# UNITED STATES PATENT AND TRADEMARK OFFICE

APPLICATION NO.	FILING DATE	FIRST NAMED INVENTOR	ATTORNEY DOCKET NO.	CONFIRMATION NO.
10/729,903	12/09/2003	Kenji Watanabe	056208.53059US	3314

## Office Action Summary

## **DETAILED ACTION**

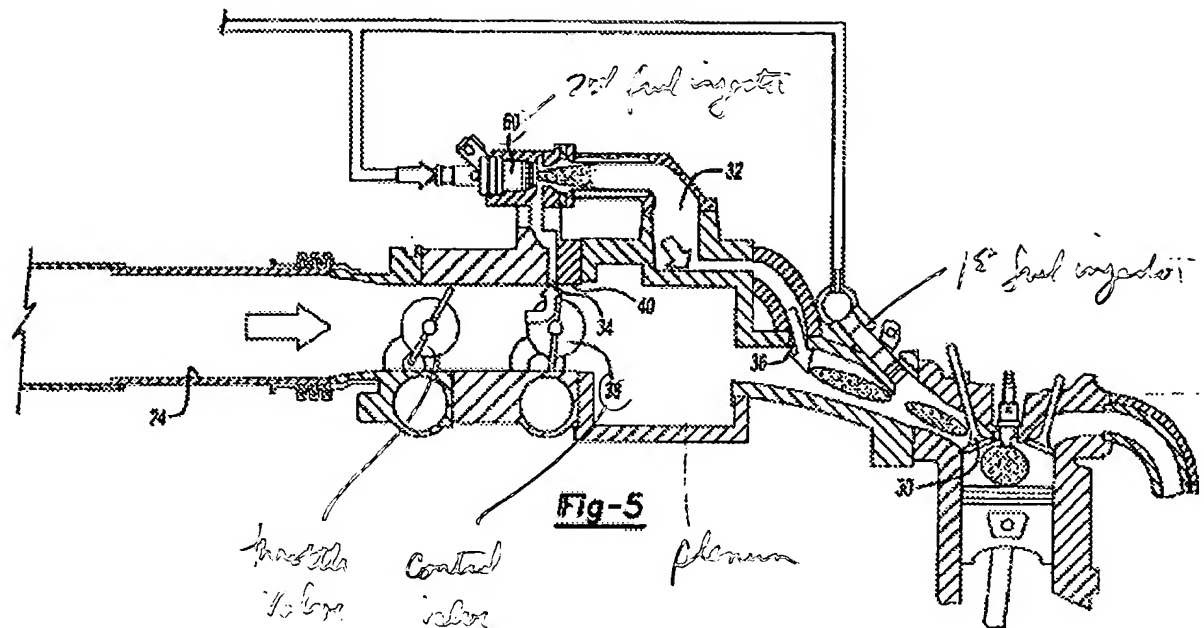
Claims 1-3, 5, 7, as best understood, and 8 are rejected under 35 U.S.C. 102(e) as being anticipated by Hunt et al (6,874,467). Hunt shows a throttle valve and a control valve 38 in intake passage 24 (see column 3, lines 13-25), a bypass 32, a second fuel injector 60 and heating means (see column 5, lines 1-10) in the bypass, and first fuel injector (unnumbered) near to an inlet port of each cylinder. The control valve 38, which is referred to as a throttle valve in Hunt et al is actuated by a motor (see column 4, lines 24-36). See also Figure 5 below:

Claims 9 and 10 rejected under 35 U.S.C. 102(e) as anticipated by or, in the alternative, under 35 U.S.C. 103(a) as obvious over Hunt et al (6,874,467). Note that Hunt et al show a plenum, unnumbered but labeled above, which is integral with the bypass outlet. The plenum implies that the intake manifold branches out into multiple passages going to the cylinders, and the fact that the bypass outlet is integral with the plenum indicates that it also has the same branched configuration. This appears to be
